7. A New Road Safety Issue

7.1 The New Location of Turbine 1

Position from where Applicant's photomontage Fig. 5.26a (1) & (2) was taken. (240432E 103113N)

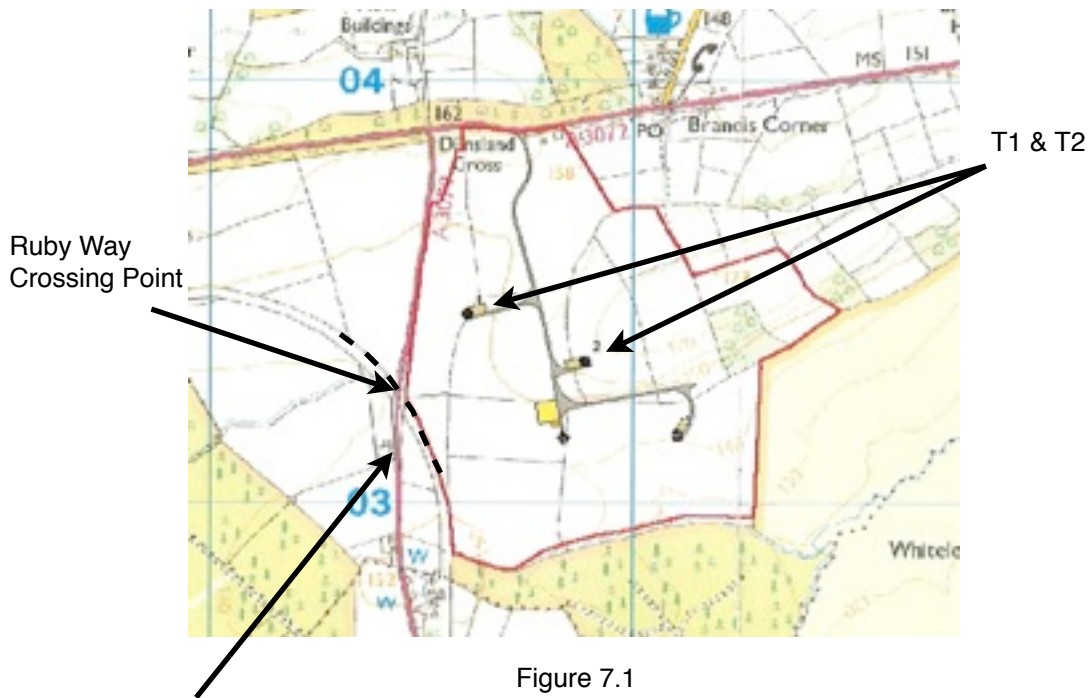
7.2.3 This is exactly the situation which arises at the Ruby Way crossing point at Dunslund Cross. The map below in Figure 7.1 shows the point of concern:

7.2.4 It is not possible in this A4-size report to reproduce accurately the applicant's ES Photomontage Figures 5.26a (1) & (2) as they extend across two full A3 sheets. The reader must, however, view the actual photomontages, rather than rely on the thumbnails above, to gain a true understanding of the magnitude of the distraction awaiting drivers travelling North at this point. It is approximately 150 metres further on to the Ruby Way crossing point, or just over 6 seconds for a vehicle travelling at the typical 50 mph road speed for this stretch of the A3079.

7.2.5 Thus drivers will be seriously distracted just 6 seconds ahead of a point in the road where they must avoid pedestrians, cyclists and horses crossing in front of them.

7.3.4 The Highways Agency and TDC should recommend that T1 is sited further away from the A3079. This will, of course, require a revised Landscape and Visual Impact Assessment (LVIA), Residential Amenity Survey (RAS) and Noise assessment to be submitted as well, to take into consideration the new turbine position.
